Central Planning Authority

Minutes of a meeting of the Central Planning Authority held on **10 April 2024 at 10:00am** in Conference Room 1038, 1st Floor, Government Administration Building, 133 Elgin Avenue

CPA/12/24

Figure 1: 2021 aerial imagery showing the break in the reef where the outflow exits creating strong currents in front of the application site outlined in light blue. (Imagery Source: UKHO, 2021)

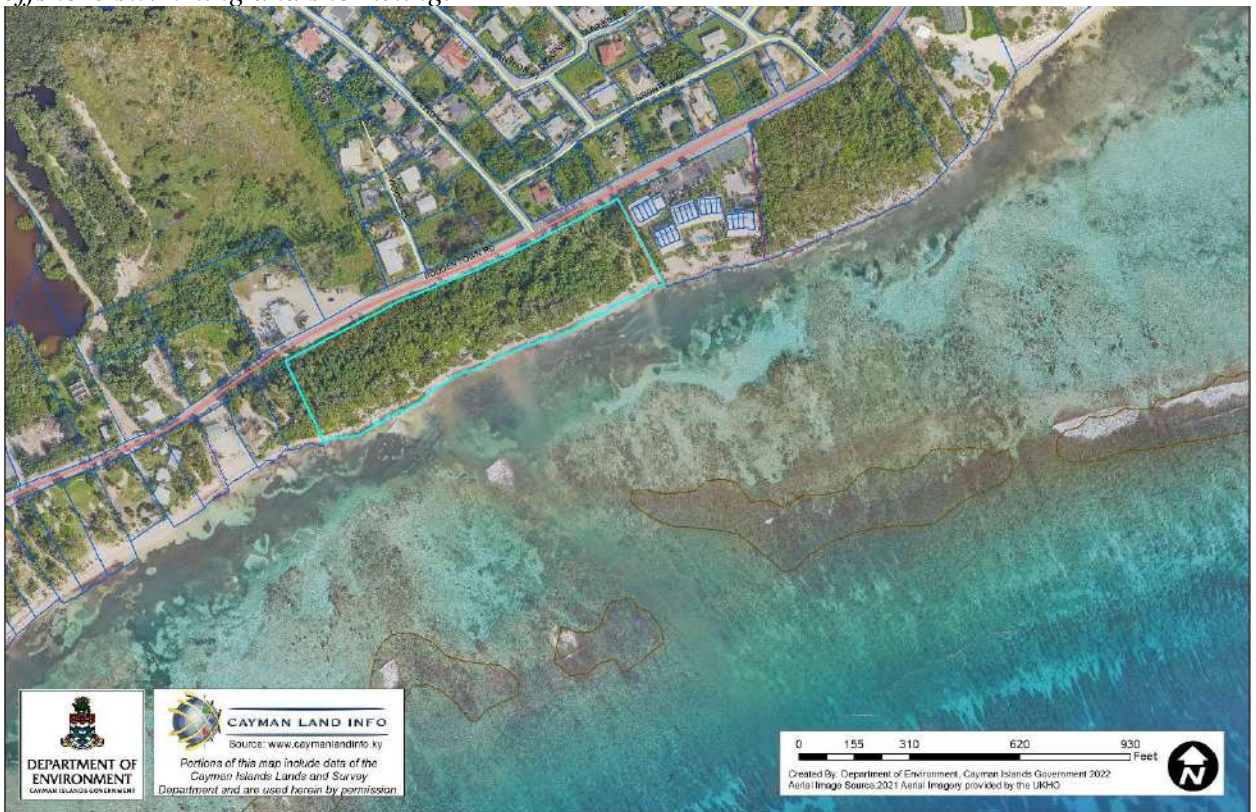
Strong Currents

The Department wishes to highlight that there are strong currents in this area. The water that comes over the reef exits through the break in the reef at this location as shown in Figure 1 below. These currents may make it unsafe for some in-water activities such as offshore swimming and snorkeling.
